B67-43001-293 EXTENSION TUBE ADJUSTMENT FITTING

RELEASED
2009-09-24
MD

DETAIL B
18 PL, SCALE 2X

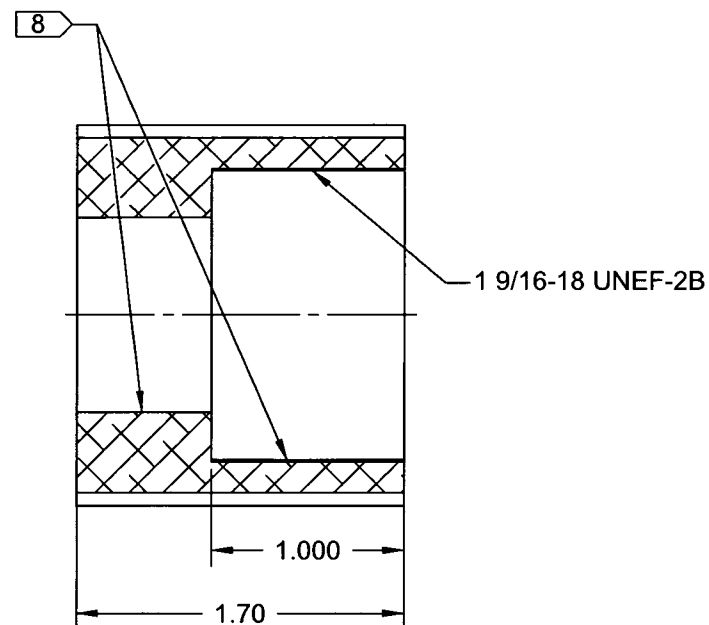
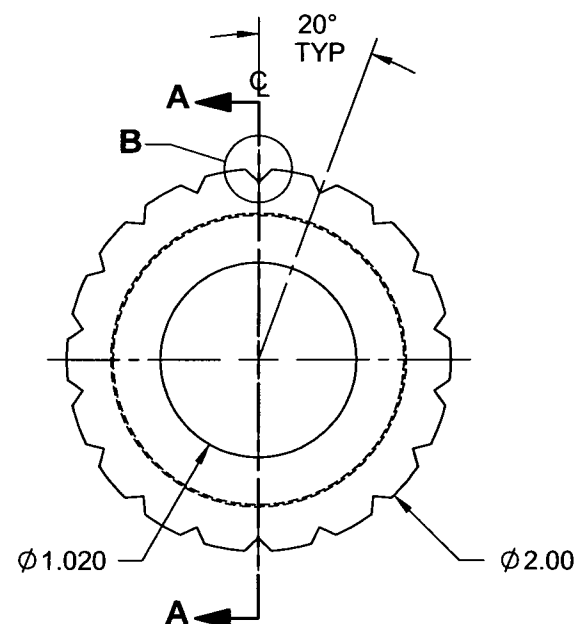
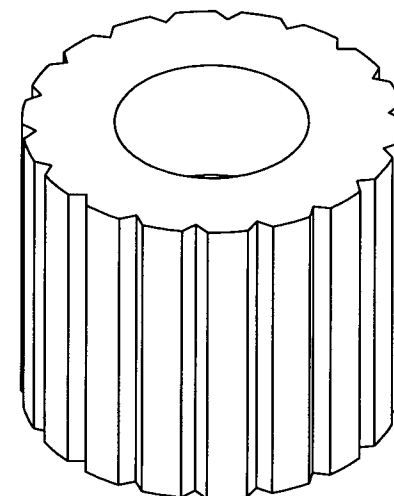
C	REDRAWN PREMIER AVIATION DRAWING IAW DART QSI 018 AND QSI 043. REPLACED INEFFECTIVE KNURL WITH GROOVES (PER DETAIL B). FOR PREVIOUS REVISIONS, REFER TO PAGE 38 OF PREMIER AVIATION DRAWING No. B67-43001. REASON: SEE PAR#09-011.		MB	09.02.26
REV.	DESCRIPTION		BY	DATE
DESIGN	RW	DART AEROSPACE LTD		
DRAWN		HAWKESBURY, ONTARIO, CANADA		
CHECKED	<i>AS</i>	DRAWING NO.		REV. C
MFG. APPR.	<i>MD</i>	B67-43001-293		SHEET 1 OF 1
APPROVED	<i>MD</i>	TITLE		SCALE
DE APPR.	N/A	EXTENSION TUBE ADJUSTMENT FITTING		NTS
DATE	09.02.26	COPYRIGHT © 1995 BY DART AEROSPACE LTD THIS DOCUMENT IS PRIVATE AND CONFIDENTIAL AND IS SUPPLIED ON THE EXPRESS CONDITION THAT IT IS NOT TO BE USED FOR ANY PURPOSE OR COPIED OR COMMUNICATED TO ANY OTHER PERSON WITHOUT WRITTEN PERMISSION FROM DART AEROSPACE LTD.
